SOURCES 101 TESTS

With regard to Walt Jung's recent article ("Sources 101: Audio Current Regulator Tests for High Performance," April '07 *aX*, p. 10), I am curious how he managed to get a one V_{be} current source to perform worse than a two V_{be} current source. My hand calculations and SPICE simulation show the one V_{be} source to be 5 to 6dB better than the two V_{be} source. In addition to having better power-supply rejection, the one V_{be} source has higher output impedance for signals originating at the collector of the output transistor. The one V_{be} source also lends itself well to simple modifications that can put both its power-supply rejection and output impedance below the noise threshold of Mr. Jung's test.

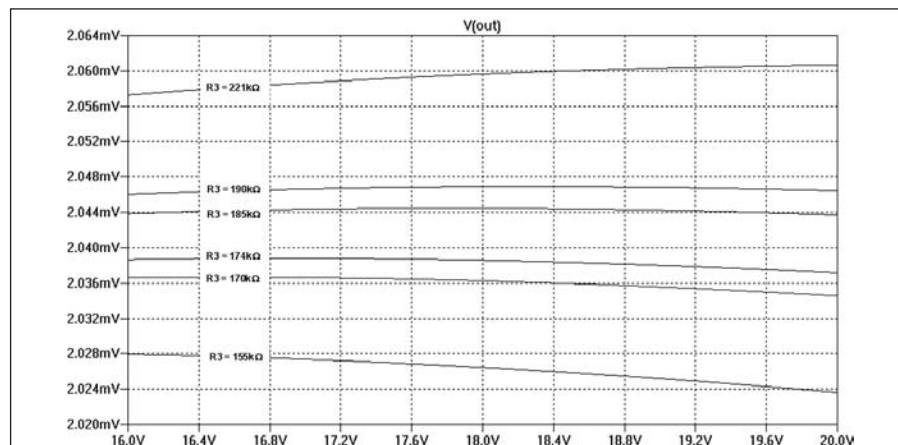
"I am wondering if you have tested the simple enhancement to the two-transistor source shown in Fig. 3A. It is based on adding a second driving resistor, with a current approximately proportional to the total supply, but connected to cancel most of the effect of supply voltage variation, over some small range.

"For instance, if you reduce the Rset resistor from 332 Ω to 316 Ω (to compensate

for the small current reduction this change causes) and connect 174k Ω between ground and the bottom of Rset, you get much higher output impedance over the whole audio spectrum, but especially at the low end.

"Adding this compensating resistor, R3, makes the circuit a little less general, because its value must be optimized for each application, depending on the expected range of the supply. But if well chosen, the improvement in supply rejection can be impressive—about 60dB improvement at low frequencies. I am pretty confident that this version can compete with any non-cascoded design on which you reported."

I tested John's suggestion for performance enhancement both with SPICE and in the lab. The SPICE analysis was done with Linear Technology's "LTSpice" package (www.linear.com/designtools/software/switchercad.jsp/). The schematic of the circuit is similar to the original Fig. 3A, but with the addition of R3 to ground, at 174k Ω , and the slight adjustment of Rset. R1 is set to 100k Ω , for the reasons cited previously. This modified circuit is shown in Fig. 2, as it was lab tested.

Figure 1 is a plot of a DC simulation in LTSpice, with the supply swept from 16–20V, while R3 is stepped through a range of values, to illustrate the nulling properties. Note that there is a null in output change with supply voltage, which is here centered within a range around 18V for the 185k Ω trace. This null range constitutes a region of very high supply rejection, as can be seen from the data. A value for R3 which minimizes sensitivity for a given supply voltage can be used as a starting point for lab tests.

FIGURE 1: A "One Vbe" type current source using a C1 bootstrap capacitor, similar to the form used by Doug Self.

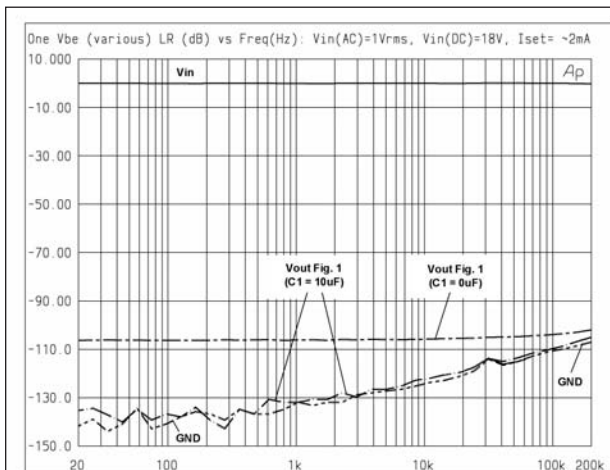
First, a few years back Doug Self briefly touched on small signal current sources and concluded that the differences in rail rejection would largely be mooted by use of a decoupling cap across the current source. I would have been interested to see whether the conclusion was repeatable and what benefit, if any, there might be when applied to the other current sources schemes described by Walt Jung.

To respond to the first item on Doug Self's form of the "One Vbe" current source, let me say that this is a worthy point. As it turns out, his variation, similar to the circuit shown in **Fig. 1**, really has excellent performance for line rejection. Readers of the original "Sources 101" articles will recognize this circuit as another variant of the "One Vbe" circuit, which was originally published as Fig. 3A in Part 1 of the article.

In the circuit of **Fig. 1** shown here, Q1 and Q2 are 2SA1016K transistor types, which have a 150V rating. These transistors are not only suitable for power amplifiers in terms of this voltage rating, but, importantly, they also feature better performance in this circuit, vis-à-vis the PN2907A general-purpose counterparts. Self's circuit uses MPSA56 types for Q1-Q2, which have noticeably higher capacitance than do the 2SA1016Ks (about a factor of 3 or more at $V_{cb} = 10V$). Lab measurements were done on this circuit operating at a supply of 18V, under conditions otherwise similar to the previous tests, with the

Note that when applying this circuit to power amplifiers operating at voltages higher than 18V, the R1 value(s)/operating point of Q2 may need attention. For reasons cited previously, the higher values for R1 might yield better results, by virtue of operating Q2 at less current. Here, the target is about 160 μ A. Self's Figure 7.5 circuit operates the transistor comparable to Q2 (his TR14) at

~2mA. For Fig. 1, the total R1 resistance is 100k. . . providing the 160μA. The equal values for R1a/R1b allow the AC bypass capacitor C1 to perform almost identically to the values of Self's circuit, where the cap value is 47μF and the total resistance is 20kΩ.

FIGURE 1: Corrected versatile line amp circuit.

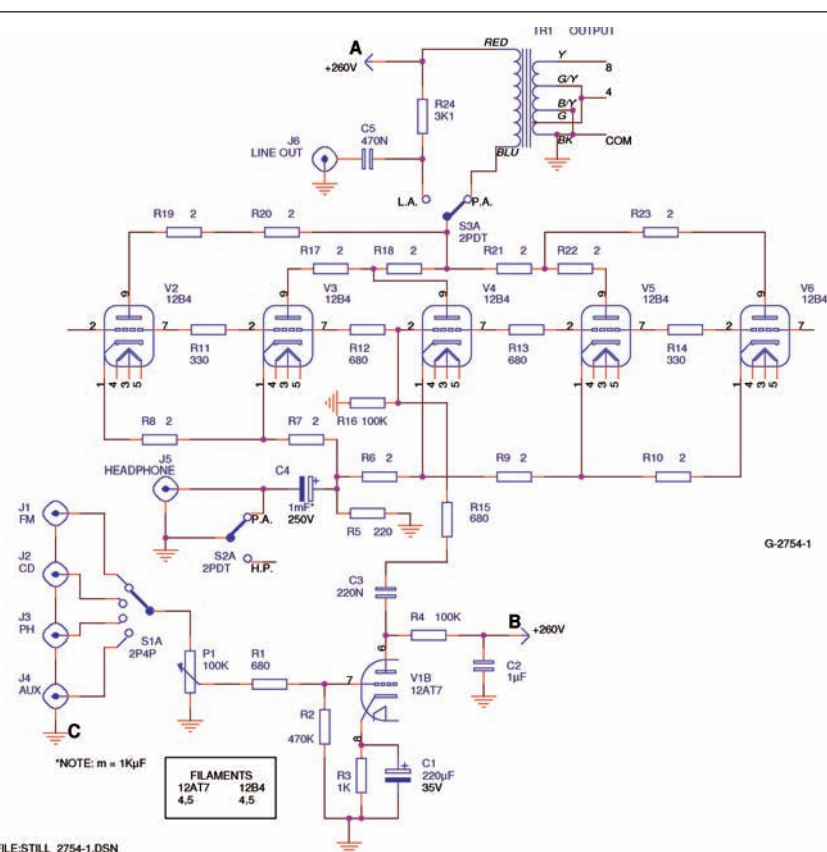
I do not understand the function switch S2a in Joseph Norwood Still's versatile line amp article. In one position it looks as though all audio is shunted to ground before it ever gets to the 12B4 tubes. Also, in the other position switch S2a shorts out all of the headphone signal, but this may allow more cathode current to flow for the power amp function. Maybe the switch is somehow misdrawn.

I noticed that the 12B4 tubes are not allowed to draw equal current. I say that because it looks as though they are not all sharing the same current in plate and cathode circuits because the diagram shows some plates and cathodes go through two and some tubes go through one resistor in both plate and cathode circuits. I am wondering whether I'm missing something.

Thank you for reading my article and the critical review. You are correct, the drawing I submitted to *audioXpress* had an error pertaining to switch S2A. Switch S2 has a wire corrected from the H.P. position to the 220N capacitor (C3). This wire must be eliminated from the circuit and all is well. The corrected circuit is shown in Fig. 1.

The second part of your question concerned unequal value of resistance between 12B4 stages. These resistors are used as carbon blocks to prepare oscillation. The small values of these cathode and plate resistors (2Ω) have no effect on currents of the 12B4s. Thus no unequal electrical balance problems are produced.
